DESIGN REVIEW: RECOMMENDATION

1422 SENECA STREET, SEATTLE, WA 98101

PROJECT #:3034493-EG

DEPARTURE MATRIX [8.0]

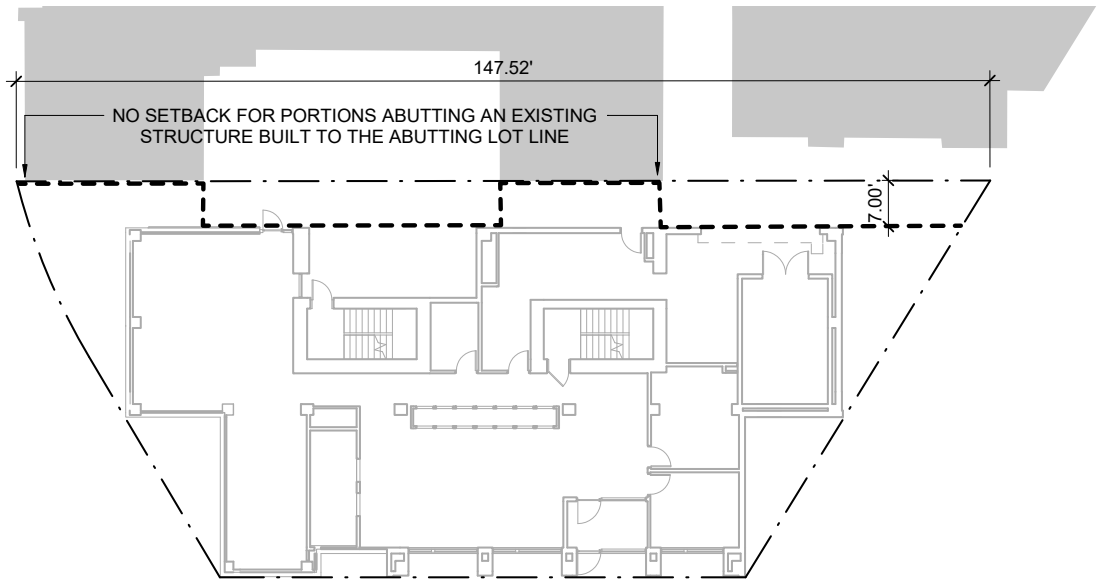
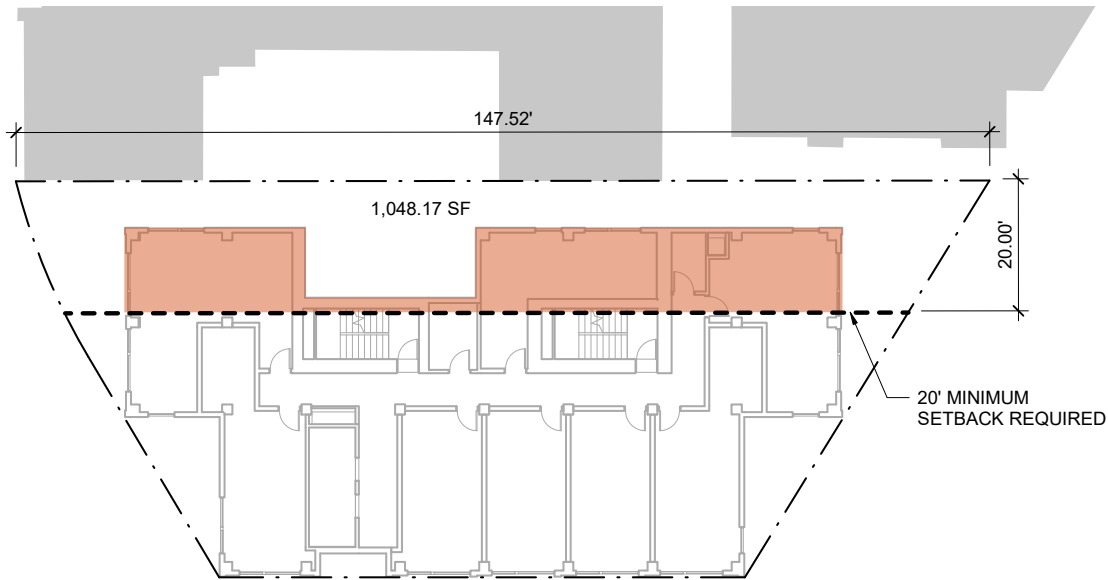
DEPARTURES
(CS2.D.3)

The Board expressed qualified support for the requested departures, recognizing their importance in creating a viable project on this unusual site and their expectation of highest quality design solutions given the magnitude of the requests.

DEPARTURES
(DC2.B.1)

The Board agreed that for the departures to be considered, a clear rationale would be required demonstrating how they help the project better meet the intent of adopted design guidelines.

The current design is consistent with the preferred scheme at EDG that was supported by the board. Dri-design metal panel is being proposed at the metal panel with a wood textured metal panel. All facades are being designed with the high quality materiality, since this will be a prominent, iconic building in the neighborhood.

The departures allow the design to be a thinner, rigorous, iconic tower as opposed to a building with the prescribed setbacks. In addition, mass timber would not be feasible with the code prescribed setbacks.
